Application No.: 09/980,009

**REMARKS**

Appl. No. 09/980,009  
 Amendment dated January 26, 2005  
 Reply to Office Action of July 26, 2004  
 Annotated Sheet Showing Changes

Fig. 2A

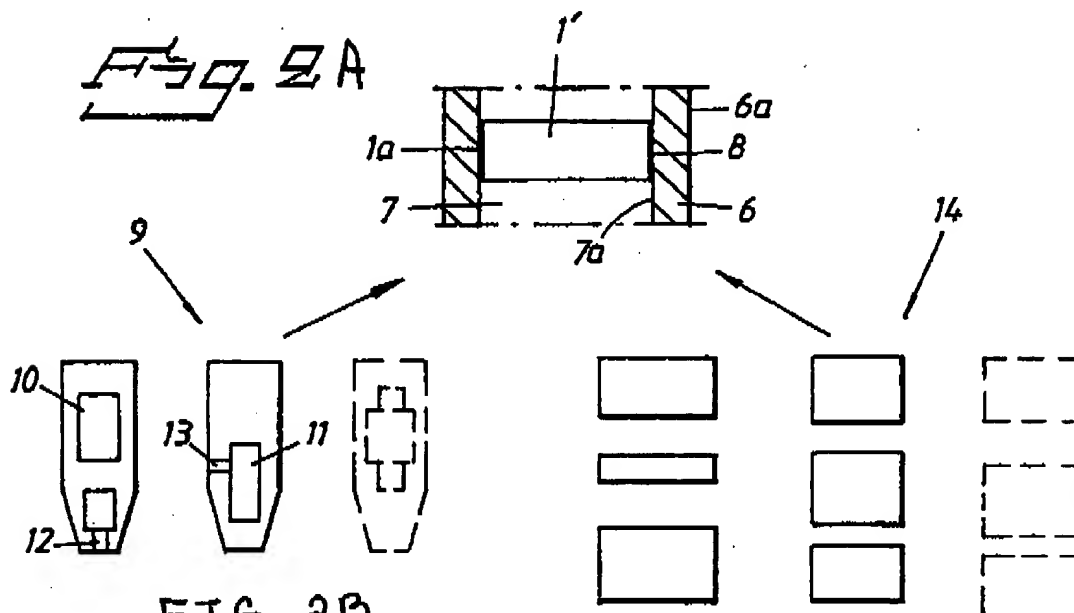
Applicants respectfully request reconsideration and withdrawal of the objection to the drawings based on the incorporation of multiple figures in FIG. 2. FIG. 2 has been amended to individually label the multiple figures previously shown therein as FIGS. 2A-2C.

The attached sheet(s) of drawings includes changes to FIG. 2.

The specification has been amended to reflect the conversion of the multiple figures shown in FIG. 2 to FIGS. 2A-2C, as required by the Examiner. No new matter has been added.
